Economic Commission for Europe
Inland Transport Committee
World Forum for Harmonization of Vehicle Regulations
Working Party on General Safety Provisions
127th session

Geneva, 15–19 April 2024

**Report of the Working Party on General Safety Provisions on
its 127th session**
Contents

Figure 4
Monocular Fields
(Direct vision case)

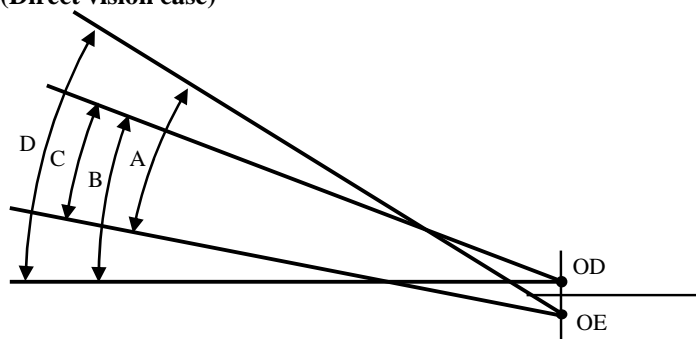
Paragraph 12.2., amend to read:

"12.2. "Ambinocular vision" means the total field of vision obtained by the superimposition of the monocular fields of the right eye and the left eye (see Figure 4 below).

Figure 7
Example of the Measurement by Maximum Variation

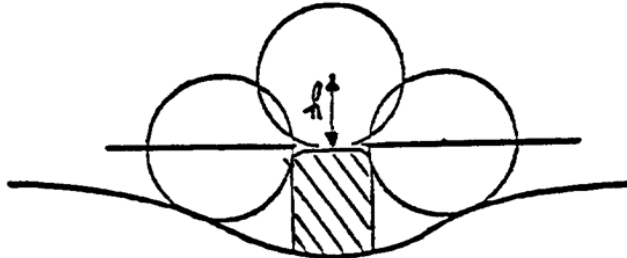
15.4.3.2.1. The dimension of the projection of a component which is mounted on a convex surface may be determined either directly or by reference to a drawing of an appropriate section of this component in its installed condition.

shall be determined by the maximum variation of the distance of the centre of a 100 mm diameter sphere from the nominal line of the panel when the sphere is moved over and is in constant contact with that component.

Figure 7 shows an example of the use of this procedure.
